Architectural Review Board Meeting Agenda

Thursday, February 13, 2025 at 5:30 p.m.

1. Project: Pfaff New Residence, Project 23-2209-ARB/CDP
Address: 5559 Calle Arena
Applicants: Jon Starr, designer, for Mark and Megan Pfaff
Planner: Syndi Souter

2. Project: The Palms Renovation, Project 24-2303-DP/CDP/ARB
Address: 701 Linden Avenue
Applicants: Laurel Perez, agent for 701 Linden LLC
Planner: Brian Banks

LIGHTING PLAN

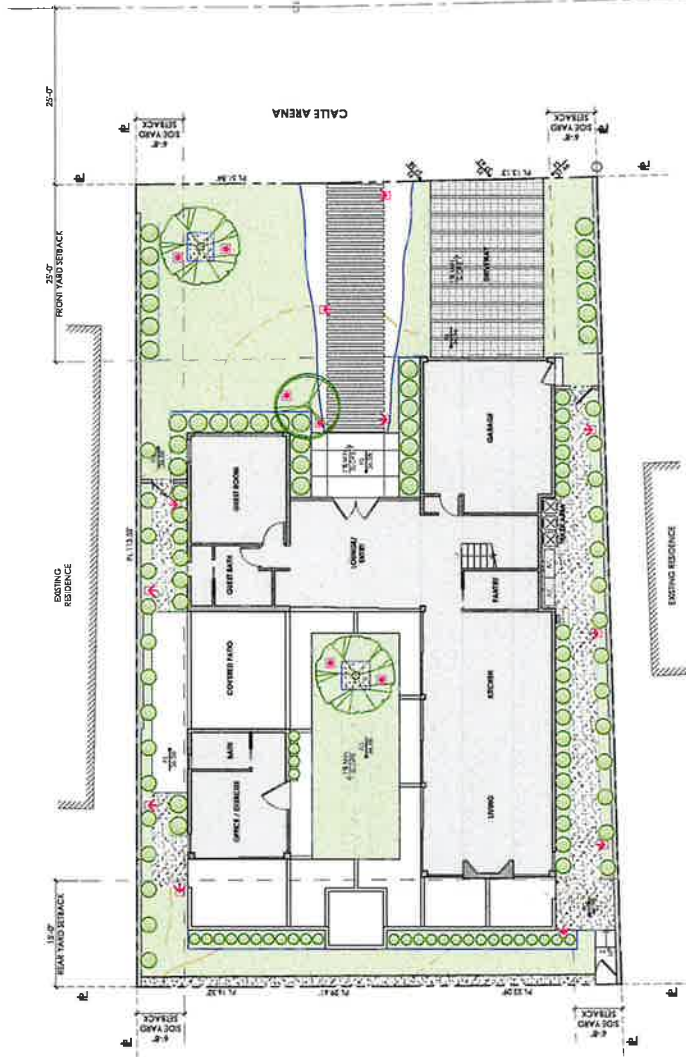
- Choose a residential type of pathway light rather than the bollard lights, and
- Add additional vertical landscaping along the rear property line to soften views, contain nighttime light, and increase privacy.

- Choose a residential type of pathway light rather than the bollard lights, and
Have included pathway lights as suggested by Vice Chair Blakemore
- Add additional vertical landscaping along the rear property line to soften views, contain nighttime light, and increase privacy.
Have replaced rear planting with Deer Grass as suggested by Vice Chair Blakemore

Exhibit 2, Proposed Signage on the Street Façade facing Linden Avenue

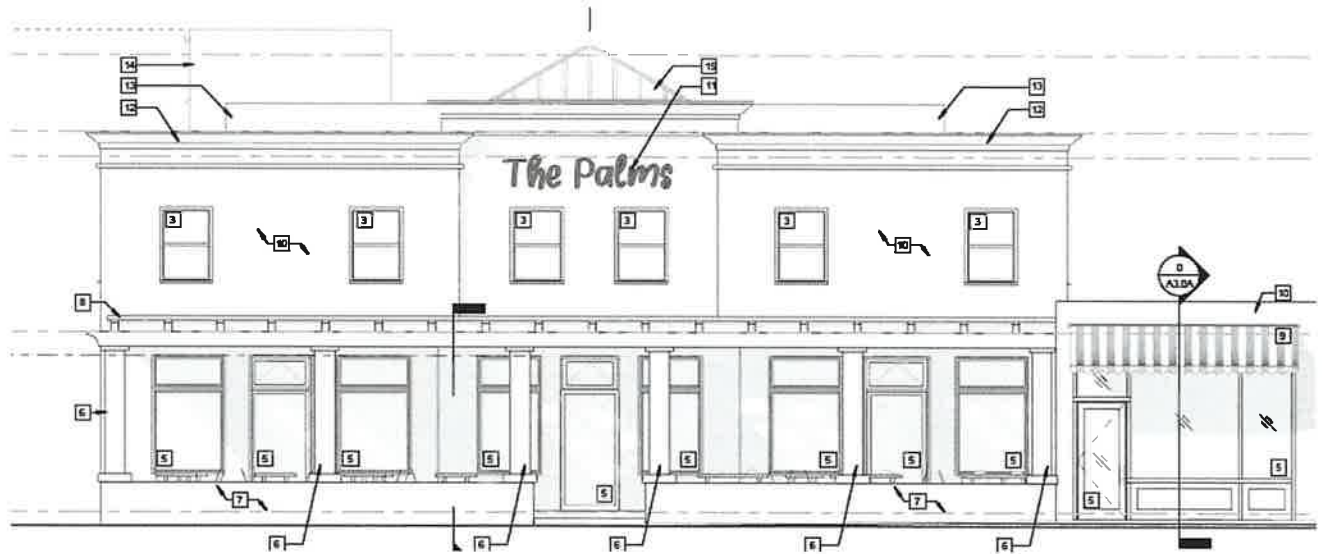
In response to the Planning Commission's comments with respect to "The Palms" signage on the Linden Avenue façade, the final plans include a new powder-coated metal sign which would replace the existing script style with a new and slightly smaller font style. This proposed signage style was reviewed by the project Historians to confirm compliance with the Secretary of the Interior's Standards for the Treatment of Historic Properties. See sheets A3.0, A3.0A, A3.0B, A3.0C, and A3.0D. The Historic Resources Memo for the proposed signage is included as Attachment E.
